# R. E. GINNA NUCLEAR POWER PLANT MANAGEMENT ORGANIZATION CHART

Figure 6.2-1

Amendment No. 33, 42, 38  
 PROPOSED

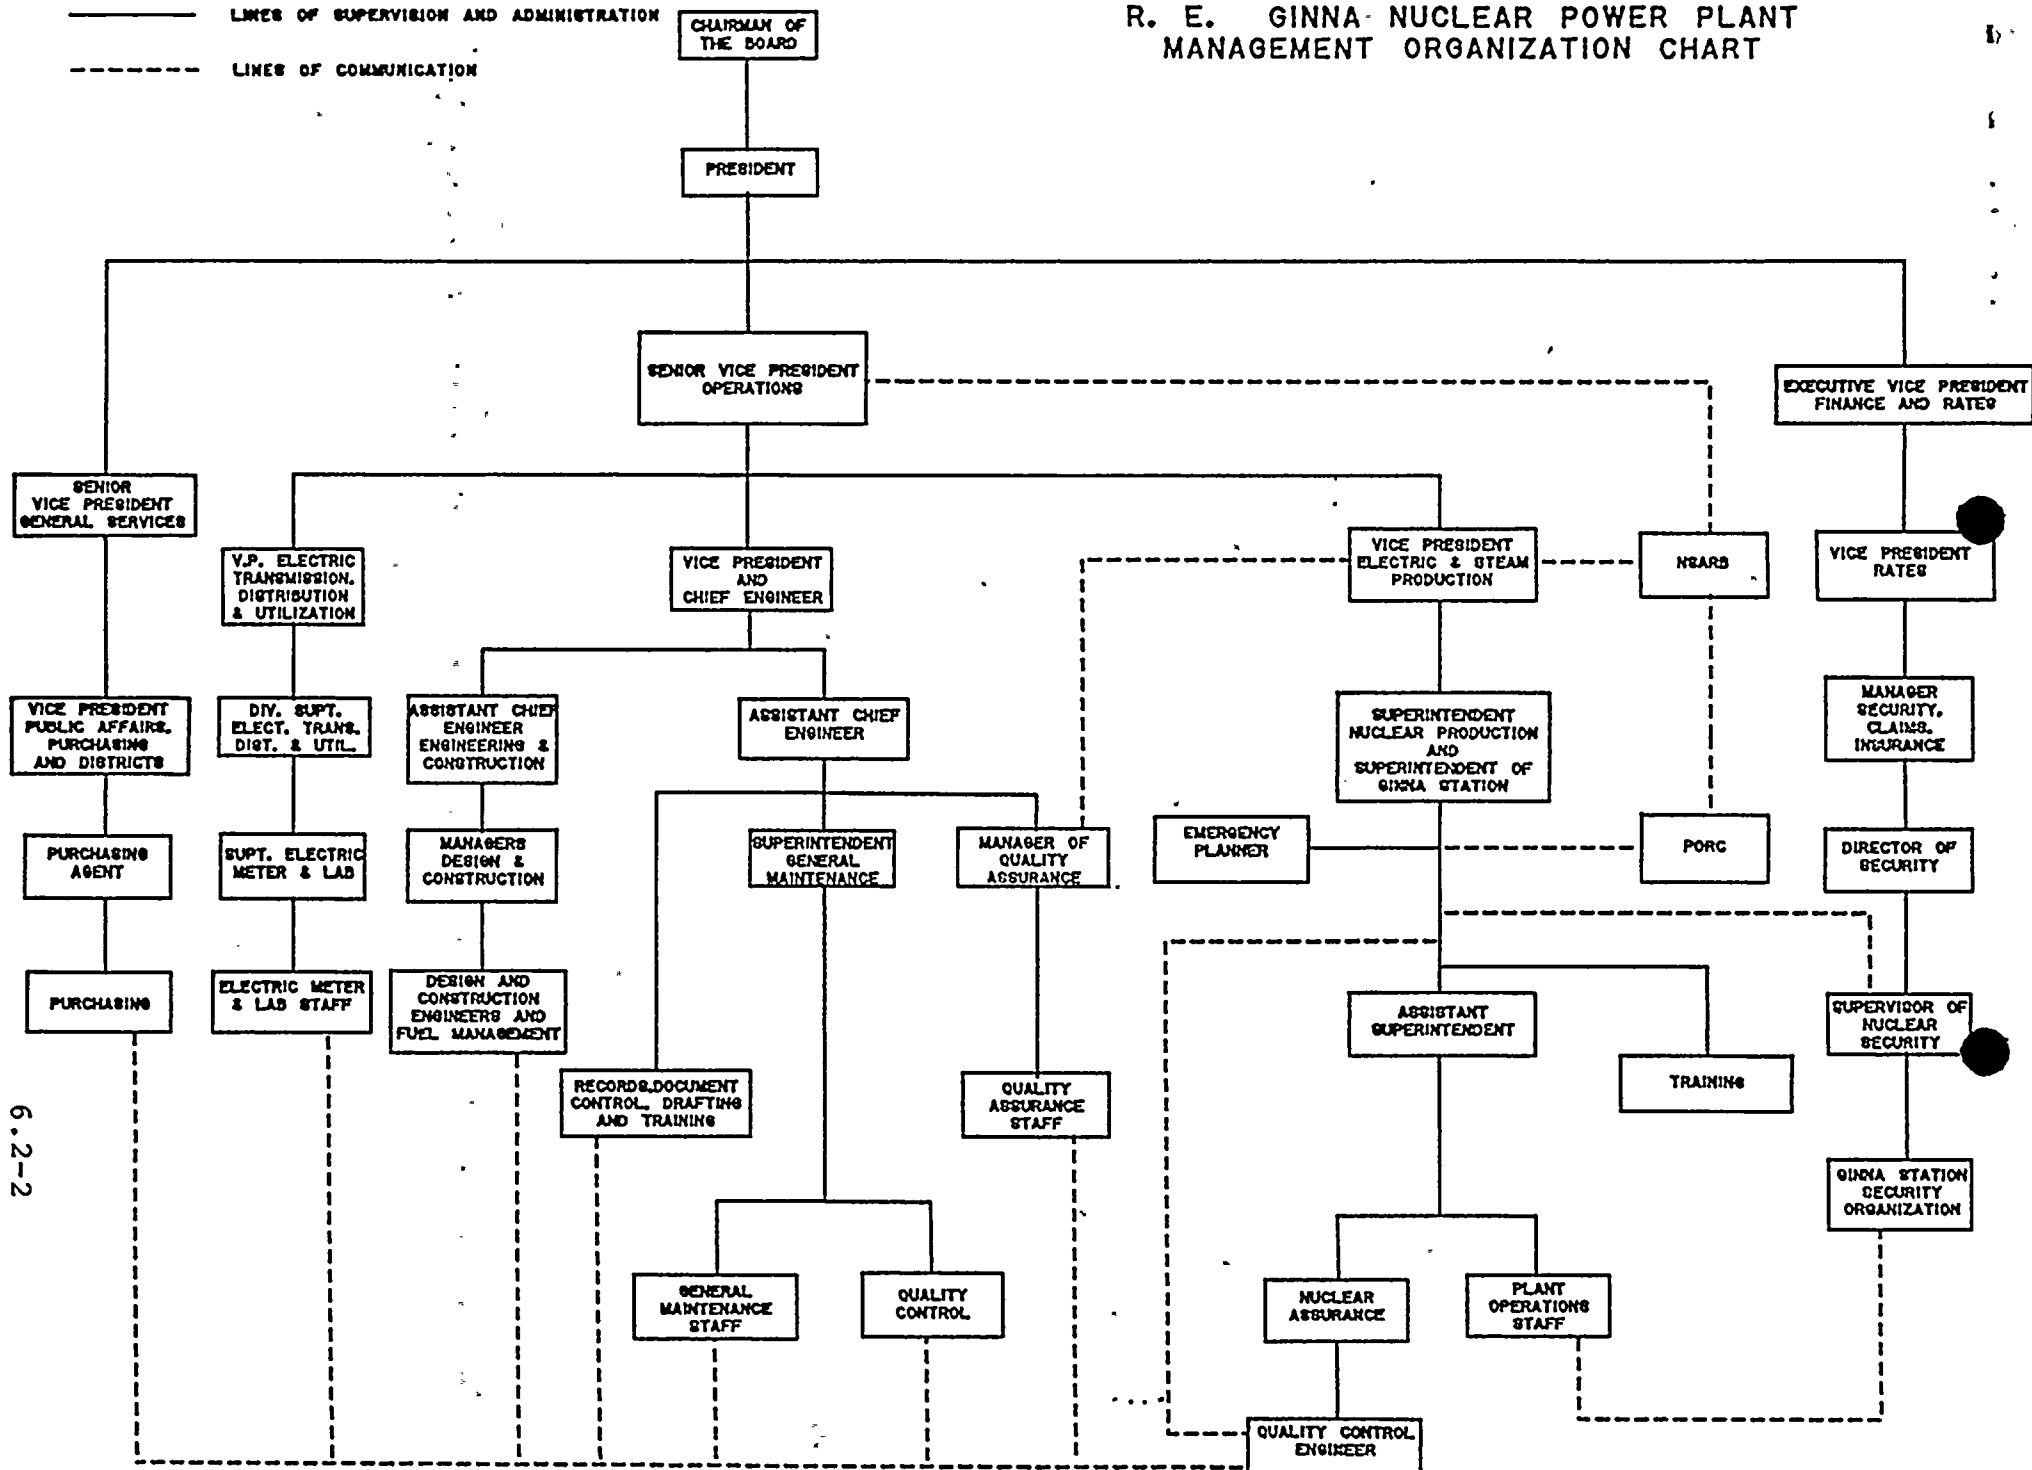
The changes reflect changes recently announced in the RG&E management which will take effect on February 1, 1984. No changes in organizational structure, lines of authority, or level of management attention to the safe operation of Ginna are being made. Minor changes in title are being made; the position of Executive Vice President becomes Senior Vice President, Operations; the position of Senior Vice President, Finance and Rates becomes Executive Vice President, Finance and Rates; and the position of Vice President, Purchasing and Public Affairs becomes Vice President, Public Affairs, Purchasing and Districts.

In addition, the dotted line indicating a "line of communication" between the Manager of Quality Assurance and the Vice President, Electric and Steam Production is being added. This line was inadvertently omitted in the issuance of Amendment No. 58.
